DEPARTMENT OF THE AIR FORCE
HEADQUARTERS 377TH AIR BASE WING (AFMC)

This letter is to summarize the decisions agreed to at the 7 March 2011 Kirtland Air Force Base (AFB)-New Mexico Environment Department-Hazardous Waste Bureau (NMED-HWB) meeting. The meeting was held to discuss the 21 February 2011 NMED letter (Atch 1) requiring continuous coring with laboratory measurements for grain size, hydraulic conductivity, porosity, specific yield, and compressibility. As agreed, the desired hydraulic parameters of hydraulic conductivity, specific yield, and grain size will be obtained through a combination of pumping tests, slug tests, and samples collected during drilling. Collecting hydraulic data in this fashion will result in the most suitable data to evaluate and design the LNAPL containment system and inform future final remedy evaluations.

FIGURE 1-1

**RE: DIRECTION TO ACQUIRE HYDRAULIC INFORMATION
BULK FUELS FACILITY SPILL (SWMUS ST-106 AND SS-111)
KIRTLAND AIR FORCE BASE
EPA ID# NM9570024423**

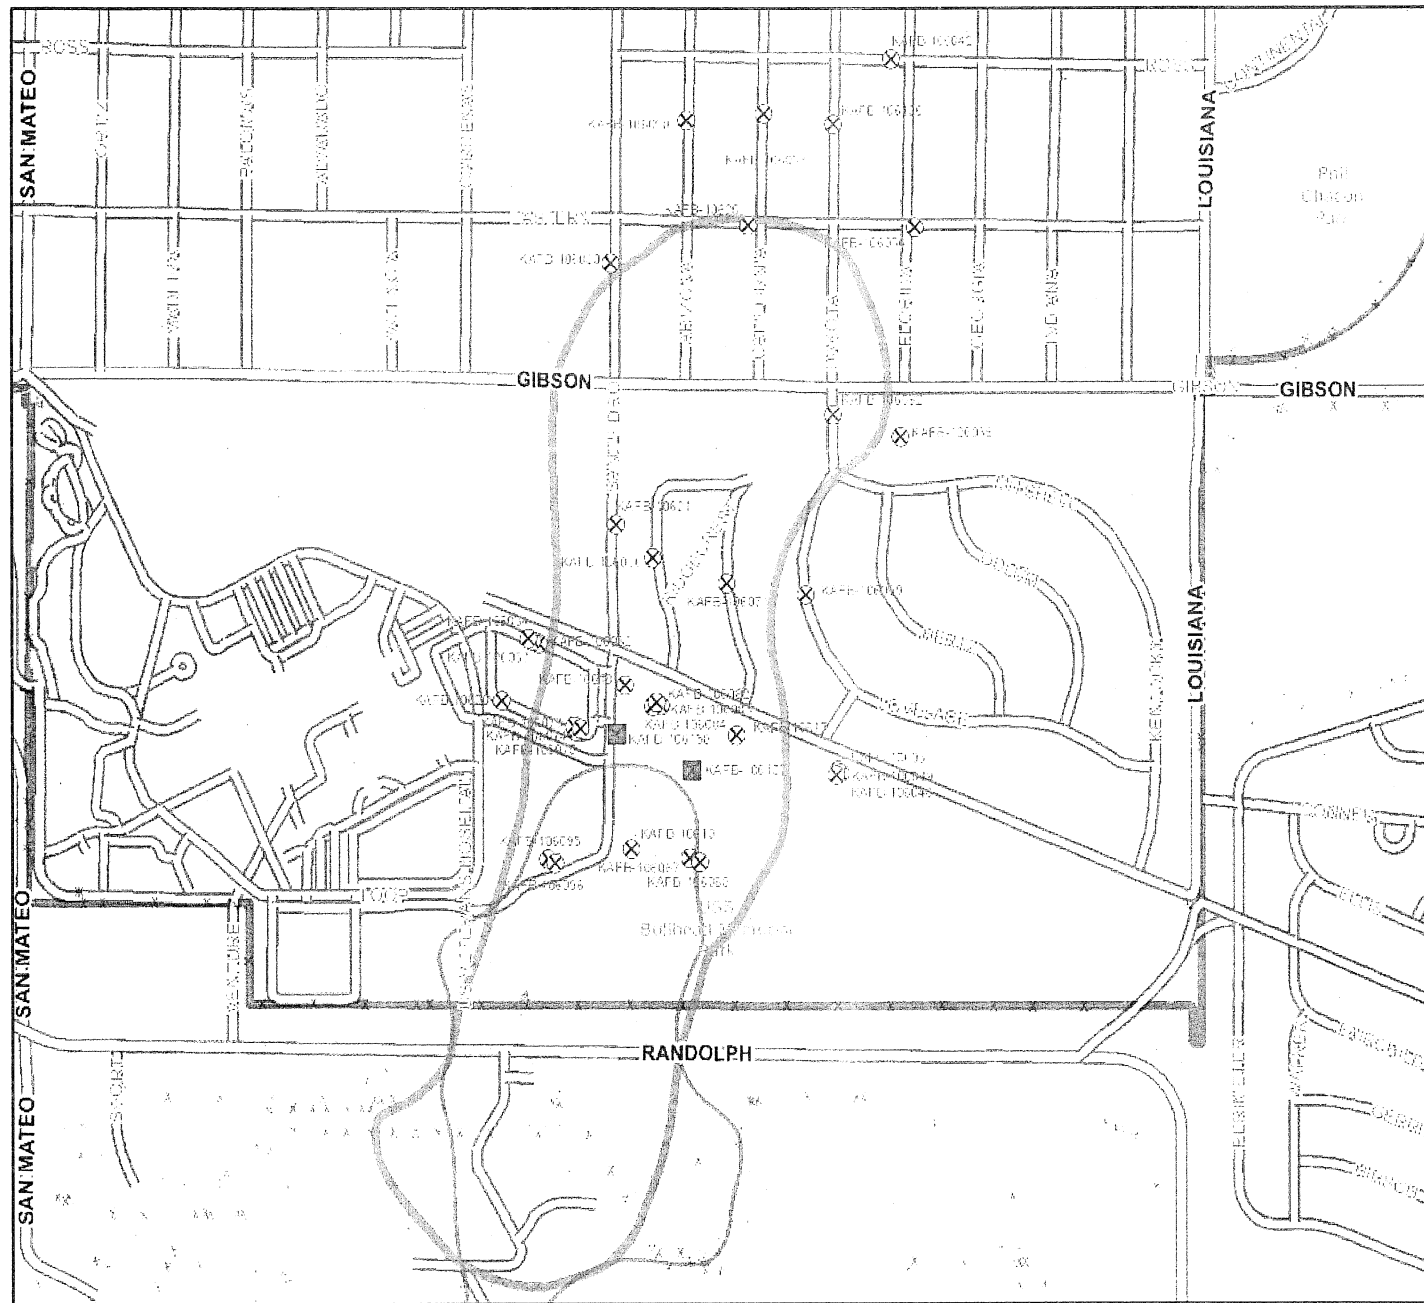
Slug tests will be conducted on all of the field groundwater monitoring well locations, as shown in the attached Figure 1-1. The slug test results will be analyzed following the oscillating slug test method (provided separate) and will yield hydraulic conductivity data most suited to monitoring contaminant migration rates. The other wells in a cluster may also be monitored during slug testing to provide an additional estimate of aquifer anisotropy.
